Re: **Rosemont Copper Project ACOE Application No. SPL – 2008-00816-MB**

This letter provides comments concerning Hudbay's final Habitat Mitigation and Monitoring Plan (HMMP; rev. 9/12/17) that was recently submitted in support of the proposed Addendum to the 401 Certification issued for the Rosemont Copper mine. To compensate for the loss of wetlands caused by mining activities, the HMMP proposes two mitigation projects, including substantial dredge and fill effort in Sonoita Creek and the removal of select stock tanks on the Rosemont project site.

Figure 1. In red, areas of former mine-related activities based on cultural resource surveys. Drill holes in yellow. Location of stock tank removals shown in green and are approximate.

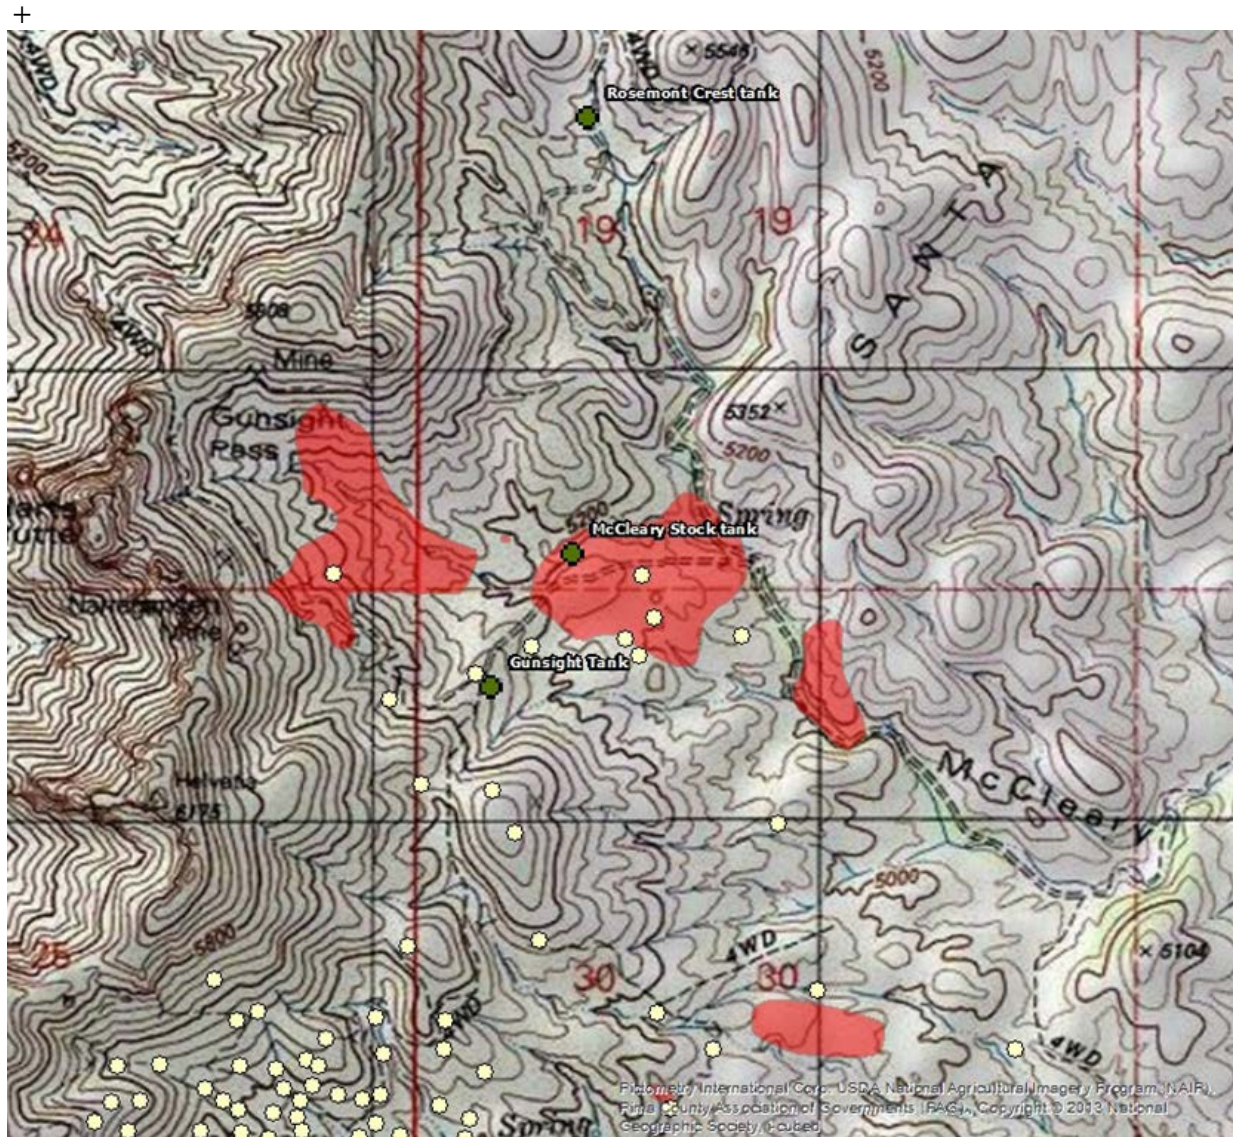
Rosemont is proposing to eliminate four dirt tanks within the project footprint to allow stormflow to be conveyed downstream. In two of the watersheds (McCleary Stock Tank and Gunsight Tank) there has been historical mining activities (see map below; red areas are historic mining sites as determined from cultural resource surveys and yellow dots are historical drill holes). The impact of disturbing soils associated with these features and conveying unknown—and unanalyzed—contaminants downstream has not been analyzed as part of the Biological Opinion or FEIS.

Hudbay (2015) data show that under current conditions, which include numerous mining features and land disturbance upstream, base flows of springs are of good quality. Elevated levels of dissolved copper, and total lead and copper have been consistently observed in stormwater at monitoring site PSW-4. Upstream spring flow met the livestock standards (Tetra Tech memorandum dated May 5, 2009). Would release of stored sediment increase ambient metal concentrations? Further study is warranted before the state can draw a conclusion that existing uses will not be impaired by the dredge-and-fill activities upstream, which include the stock tank removals. The stock tanks in the upper McCleary watershed are located below old mining claims which were historically worked (Figure 1).
